**Attachment 7**  
**Public Comments and Staff Responses to Comments**

Amendment to the Water Quality Control Plan for the Central Coastal Basin to Adopt Total Maximum Daily Loads for Turbidity in the Gabilan Creek Watershed, Monterey County, California  
(Resolution No. R3 -2022-0002)

February 2022

**Figure 1. Compilation of 164 stormwater samples collected from Salinas City outfalls over a three-year period and analyzed for both turbidity and TSS. Note the strong and consistent correspondence.**

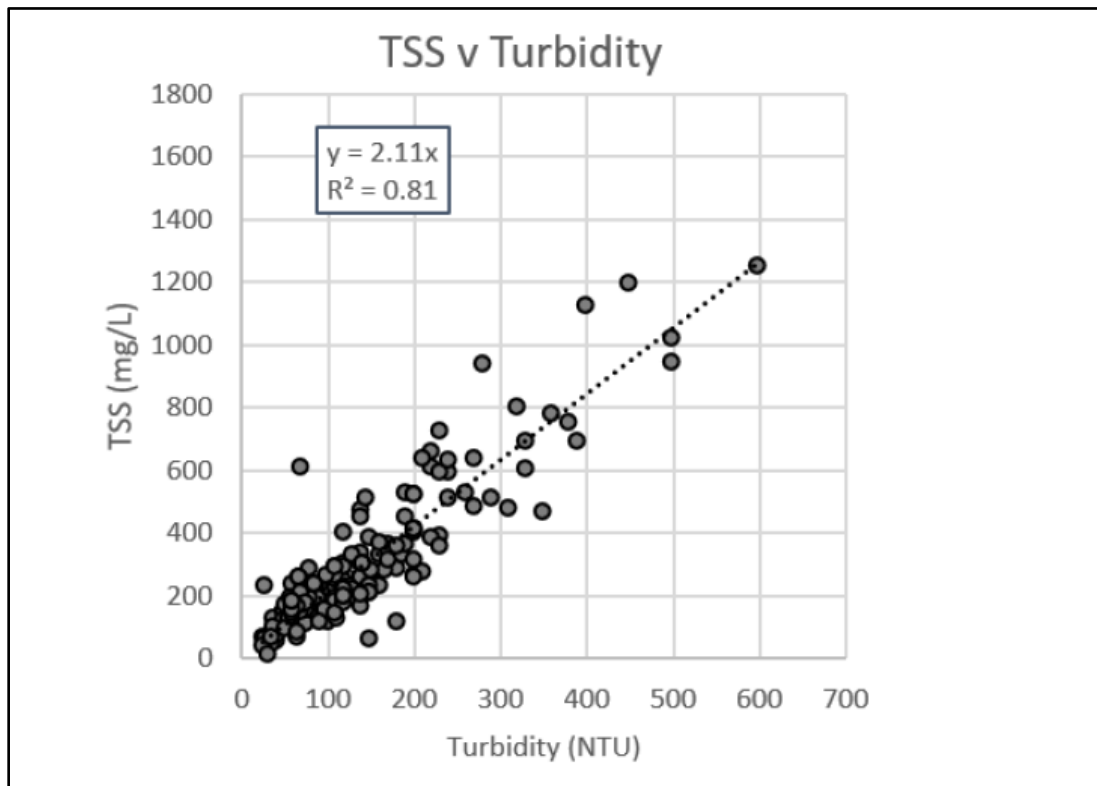
Total Daily Maximum Daily Loads (TMDL): - TMDLs are defined on page 23 of the Technical Report as: “A numerical calculation of the loading capacity of a water body to assimilate a certain pollutant and still attain all water quality standards. The sum of the individual waste load allocations (WLAs) for point sources, load allocations (LAs) for nonpoint sources and natural background, and a margin of safety (MOS).” Page 14 describes the Turbidity water quality objectives in nephelometric turbidity units (NTUs) which is a measurement of the optical measure of stream water clarity. The report continues to use NTUs as the measurement to implement the turbidity TMDL. There is no clear explanation on how the Regional Board considers NTUs, a measurement of water clarity, a viable substitution for WLAs and LAs, which are reported in mass per unit time. Section 8.2 Linkage Analysis on page 97 fails to establish the connection with any supportable explanation. Section 8.3 Allocations on page 97 leads the reviewer to believe that NTUs are a measurement of load allocations which they are not.

Uncontrollable sources should be included in the allocations.

**Turbidity, or water clarity, measured using turbidity meters and reported as nephelometric turbidity units (NTU), is an appropriate measure for a TMDL. USEPA guidance specifically states that TMDLs can be expressed as “mass per time, toxicity, or other appropriate measure, depending on the type of waterbody or sources that contribute to impairment” (USEPA, 2000). Turbidity is an appropriate measure of suspended sediment and other suspended particles. Figure 21 in the TMDL technical report (Attachment 2) illustrates how turbidity correlates to suspended sediment concentrations. Recently, the City of Salinas evaluated the turbidity and total suspended sediment (TSS) concentrations in stormwater (see Figure 1) and found a strong and consistent correlation between turbidity measured as NTUs and TSS (2NDNATURE, 2020). Streams in the lower Gabilan Creek watershed are identified on the 303(d) List of impaired waters as impaired for turbidity, and the TMDL Project address these impairments. The TMDL technical report describes how turbidity is directly linked to impairment of beneficial uses and specifically aquatic life and migration. Additionally, turbidity can impact recreation and drinking water beneficial uses of water.**

**Uncontrollable sources, such as undeveloped areas and woodlands, are appropriately included in the TMDL allocations and are assumed to meet those allocations since these areas are in natural condition and are not identified as significant sources of turbidity in the TMDL technical report.**

**Figure 2. A map of pump stations in the Gabilan Creek watershed operated by MCWRA and monitoring results.**

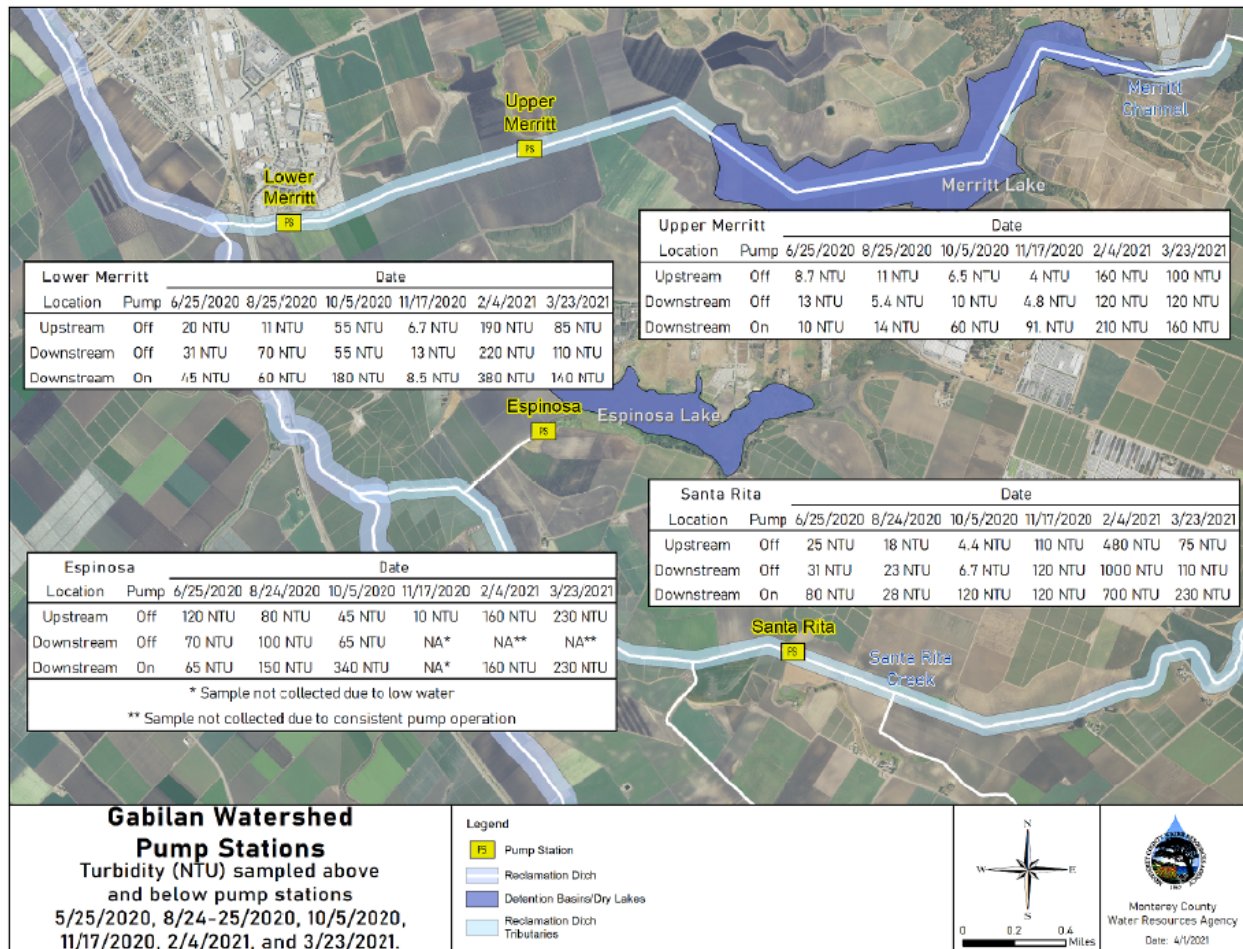
Section 7.3 Pump Stations, Agricultural Drainage Pumps and Tile Drains, page 83 - MCWRA collected water quality samples in simulated exercises during which lift stations pumps, that would not otherwise be operational, were turned on. These sampling events were not conducted with a QA/QC plan nor intended to mimic actual operational conditions nor was there a large enough dataset to make definitive conclusions. Any turbidity increases from the simulated operations cannot be directly correlated to normal operations because upstream conditions are usually different under the normal pump operations.

**Staff Response (SR-8):**

**Staff acknowledges that MCWRA monitored their pumps without a quality assurance and quality control plan (QA/QC plan). Although the data may lack documentation on accuracy and precision that would be required by a QA/QC plan (e.g. calibration and drift checks), the data are useful to determine relative difference in turbidity in upstream and downstream locations (refer to Figure 2). Further, the results of the MCWRA monitoring are consistent with turbidity levels measured by regional monitoring programs at stations nearby pumps (see summary data in section 3 of the TMDL technical report (Attachment 2). MCWRA staff did sample five separate events from June 25, 2020 to March 23, 2021 and collected nearly 60 samples. This sample size, in the context of regional monitoring data documenting typical conditions near the pumps, provide a useful dataset for understanding the impact of the pumps on turbidity and indicate that the pumps are a source of turbidity.**
